SERVICE LETTER

No. 637

Subject: Rajay Service Letter No. 19, dated September 5, 1972.

RAJAY INDUSTRIES, INC.
SERVICE INSTRUCTION

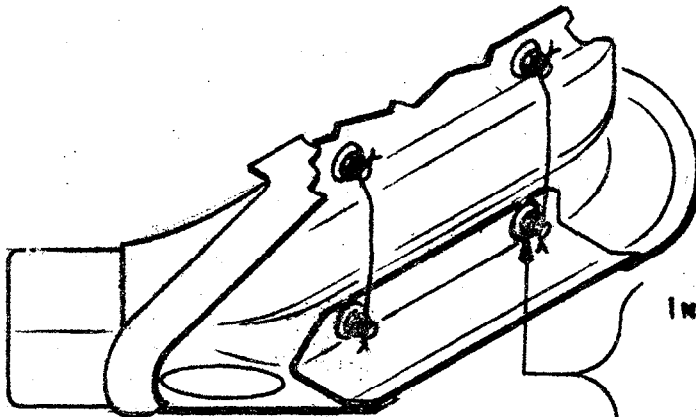
THERE HAVE BEEN ISOLATED REPORTS OF THE TURBOCHARGER INDUCTION DUCT RETAINING STUDS BACKING OUT AND BEING INGESTED INTO THE COMPRESSOR SECTION OF THE TURBOCHARGER. TO PRECLUDE THIS FROM OCCURRING ON ANY FUTURE INSTALLATIONS, A REVISED ASSEMBLY WILL BE USED AS SHOWN BELOW:

INSTALL:
NAS 183-4-8 STUD
AN 310-4 NUT
4 EACH REQUIRED
SAFETY WIRE (.030 DIA.) PER
MS 33540 TOP TO BOTTOM AS SHOWN
2 PLACES
